Project Summary

The applicant has submitted an application for a major commercial site plan located at 142 E Granville Street, parcel #41741201017003. The site plan calls for the renovation of an existing 1,536 square foot building and the construction of a 1,512 square foot addition on the south side of the existing building, as seen below.

Figure 2: Building Site Plan and Parking Lot

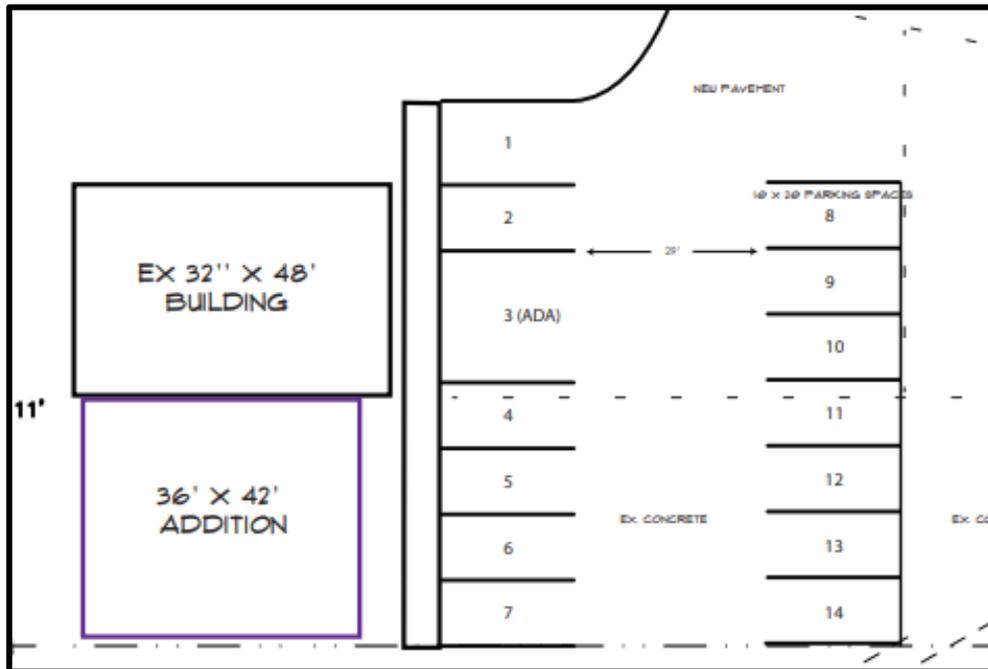
-
3. Staff agree with the submitted parking analysis provided by the applicant. Based on the expected students and classrooms, and the city's parking requirement for school, trade/business, or cultural art uses, fourteen (14) parking spaces should be adequate for the property.

5. This site plan abuts State Route 37, which is planned to be widened and includes a multi-use trail added near the west side of the proposed building. Staff would recommend delaying the installation of arborvitae on the west side of the building until the widening project is completed, to avoid the removal of landscaping.
